SUBJECT: Request for Exemptions from Development Regulations
Pursuant to Chapter 201H-38, Hawaii Revised Statutes (HRS)
Project: Fort Street Mall Affordable Senior Rental Housing
Landowner: Roman Catholic Church in the State of Hawaii
Applicant: Catholic Charities Housing Development Corporation
Agent: R.M. Towill Corporation (Isaiah Sato)
Location: 1155 and 1159 Fort Street Mall – Honolulu
Tax Map Keys: 2-1-010: 033 and 034

DEPARTMENT OF PLANNING AND PERMITTING
OF THE CITY AND COUNTY OF HONOLULU

PROJECT:	Fort Street Mall Affordable Senior Rental Housing
LANDOWNER:	Roman Catholic Church in the State of Hawaii
APPLICANT:	Catholic Charities Housing Development Corporation
AGENT:	R.M. Towill Corporation (Isaiah Sato)
LOCATION:	1155 and 1159 Fort Street Mall - Honolulu (Exhibit A)
TAX MAP KEYS:	2-1-010: 033 and 034 (Lots 2, 3, and 4)
LAND AREA:	6,900 square (sq.) feet (ft.)
STATE LAND USE:	Urban District
DEVELOPMENT PLAN AREA:	Primary Urban Center
ZONING:	BMX-4 Central Business Mixed Use District (BMX-4 District)
EXISTING USE:	Vacant two-story commercial/office building
SURROUNDING LAND USE:	Office buildings, meeting facility, personal services, eating and drinking establishments, un

Exhibit C-1

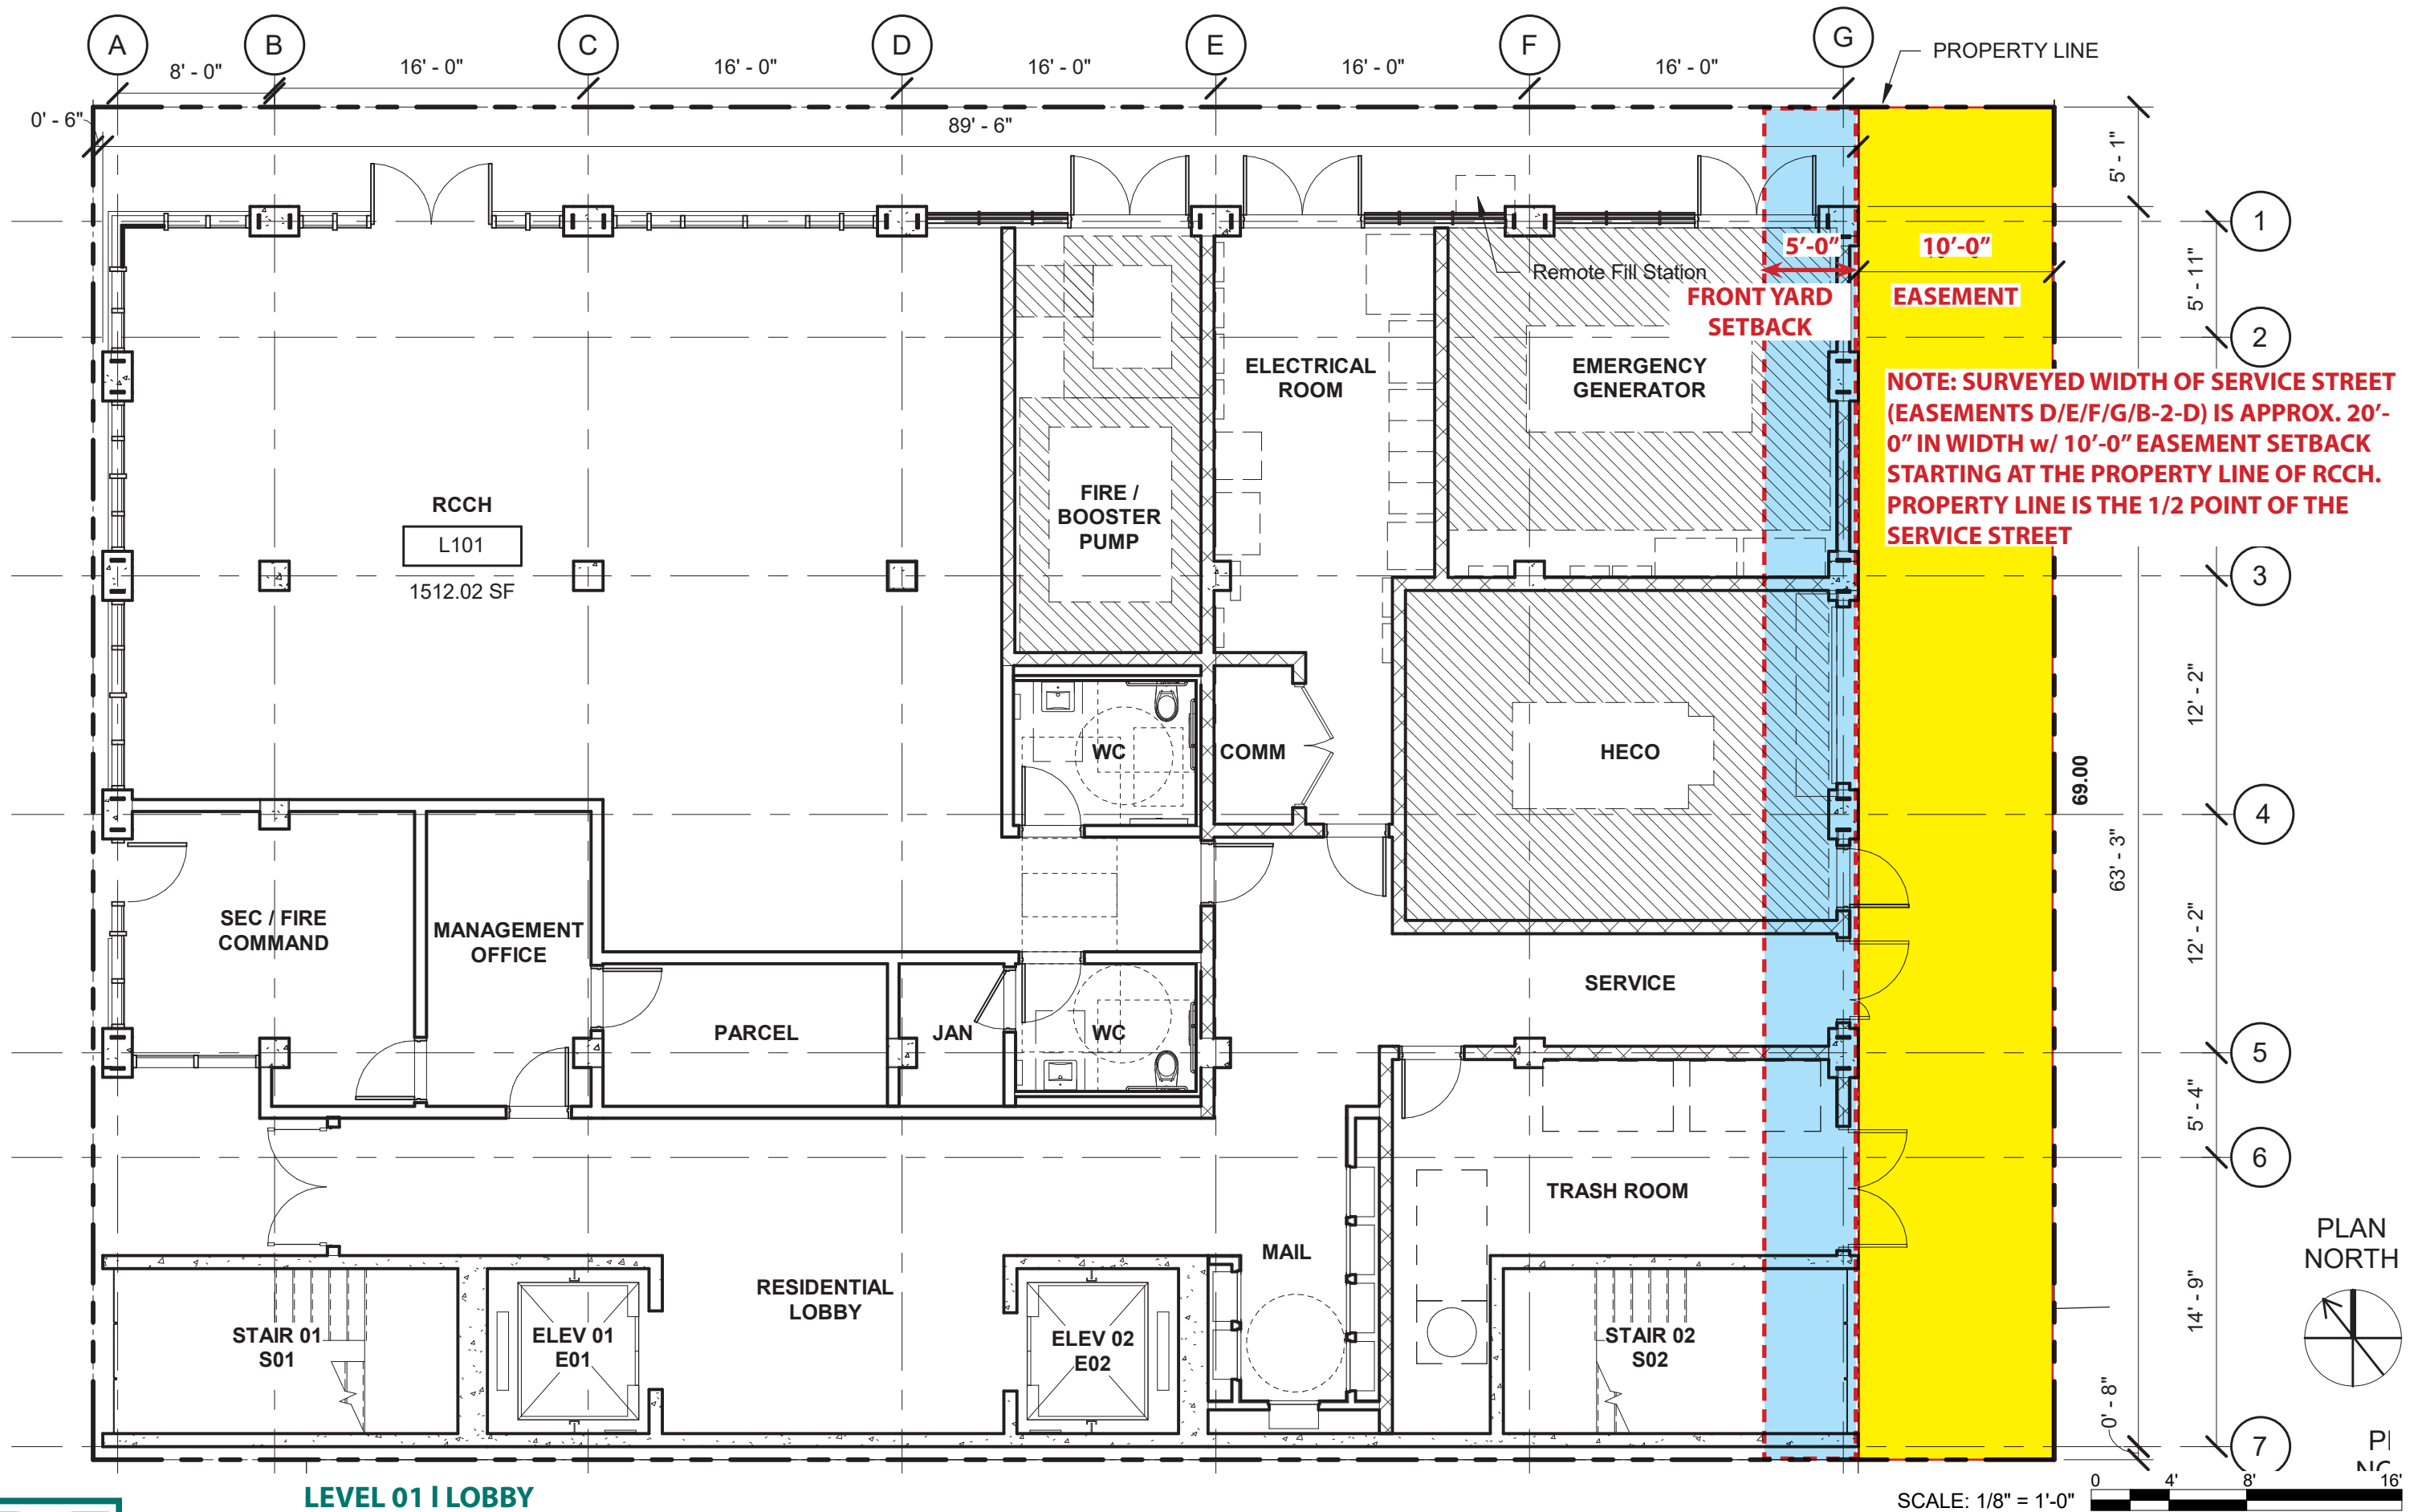
separately below. The existing service lane, which straddles the Project site and the neighboring lots, is considered a street for purposes of the LUO (see Exhibit C-1). While no off-street loading space is proposed, the service lane provides vehicular access to the site, so loading activities, such as passenger loading and/or unloading, trash pickup, and maintenance of the electrical room and generator could be performed. As previously mentioned, the service lane is comprised of multiple access easements, so while these loading activities could potentially be performed here, it does not constitute a designated off-street loading space for the Project. However, the Traffic Assessment (TA) submitted did not provide enough detail for the DPP Traffic Review Branch (TRB) to perform a sufficient review of the proposed use of the lane. The TA did not include a detailed layout showing how vehicles would maneuver on and off site. Additionally, the TA did not include a description of the commercial component and the estimated number of trips generated. Further, the TA did not account for existing users of the service lane or evaluate potential impacts from the Project development or additional users of the service lane upon project completion.

Given all this, further analysis is required in order to determine whether the service lane can accommodate the increase in traffic. A new TA should be done that includes a detailed layout showing how two-way traffic will be provided, where loading activities will occur, that vehicles are able to safely turnaround and exit without having to reverse out, how many trips are generated by the commercial space, and whether there are any impacts when accounting for the existing users. If the new TA shows that the service lane is able to support the increase in vehicle traffic or if the TA is able to provide recommendations for how to mitigate any potential impacts, then DPP does not object to the reduction in loading space.

Exhibit C-3

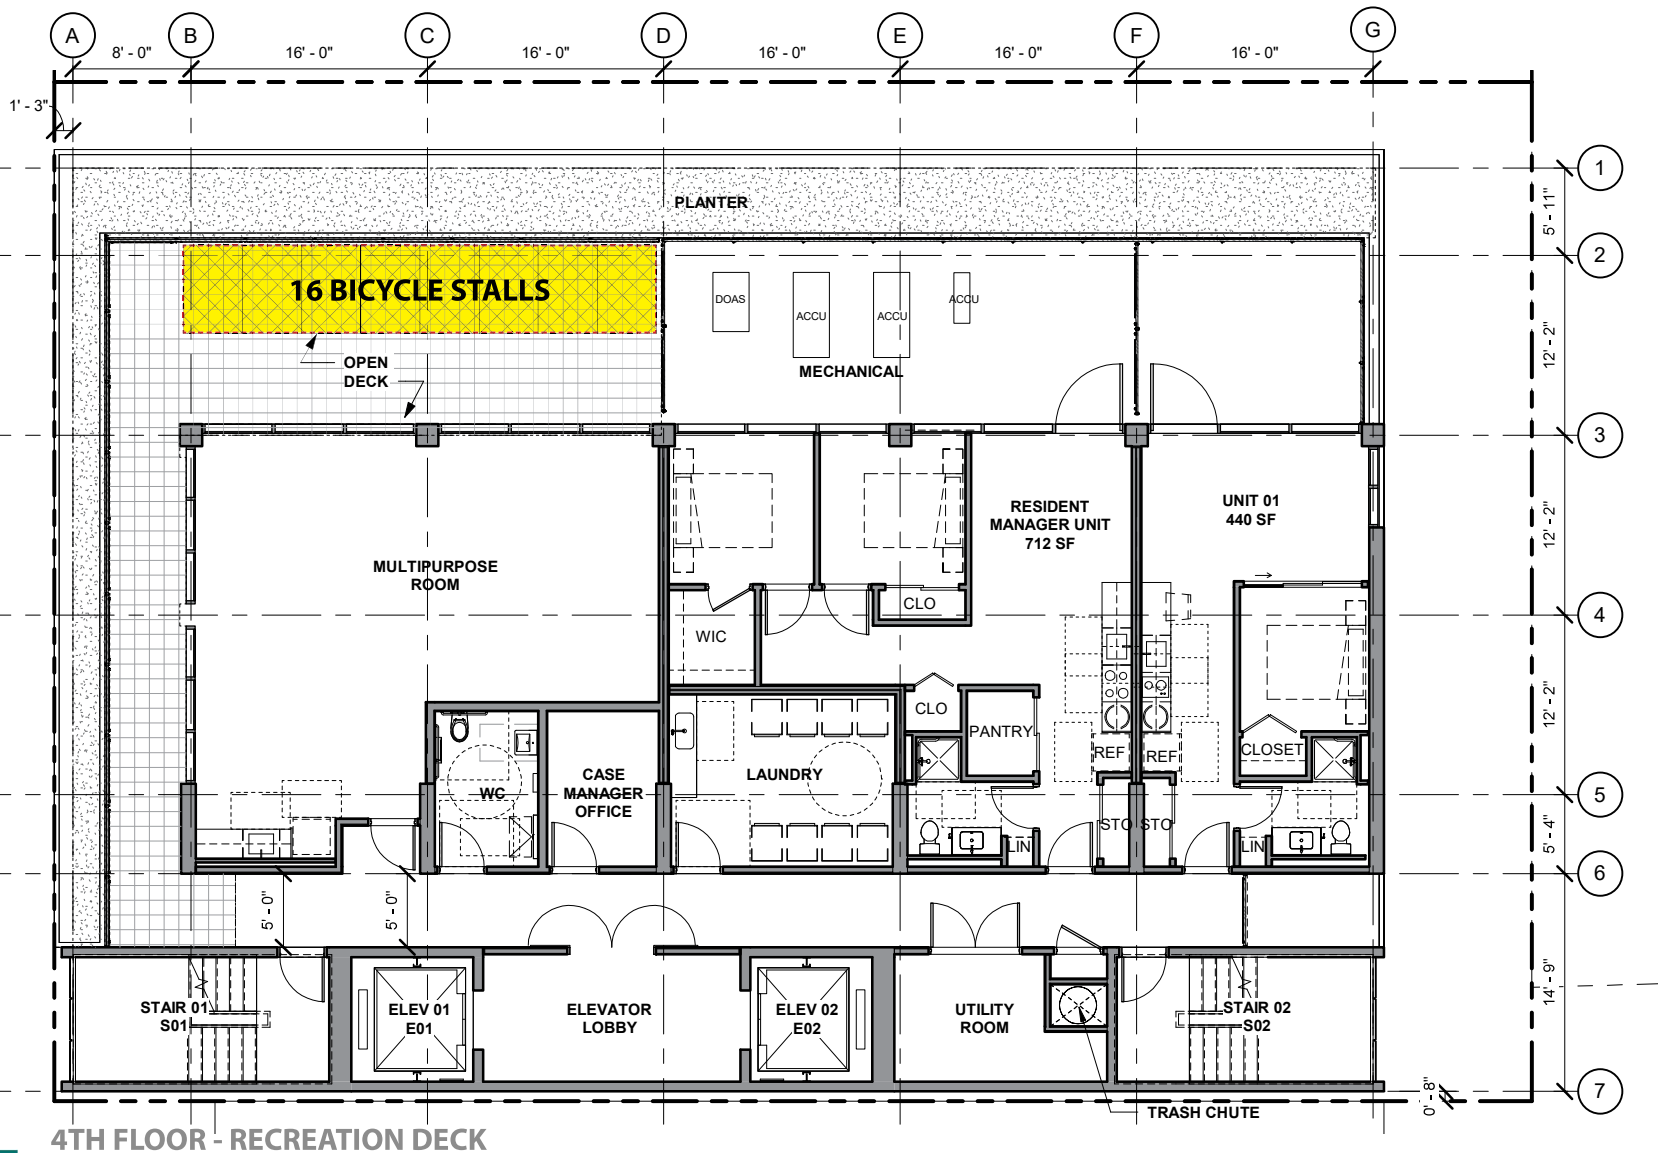
- ii. Yards: The existing service lane at the rear of the Project (opposite from Fort Street Mall) provides access to more than two zoning lots, and therefore it is considered a street for development purposes. Given this, a five ft. required yard would apply along Easements D, E, and F (See Exhibit C-3). The plans show that the proposed building encroaches into the required front yard, which is supposed to be landscaped in the BMX-4 District (see Exhibit C-3).

The requested exemption will allow better use of the site, which is in a highly urban area. The existing building already encroaches into the front yard, and circulation along the service lane will remain unchanged. However, the height of the new building will add more bulk along the service lane, which will increase the scale and shadows of the building. As discussed previously, the Applicant should incorporate design elements to ensure the lower levels are pedestrian oriented.

provided the Applicant mitigates the visual scale of the building, we recommend that the yard encroachment for the building be approved.
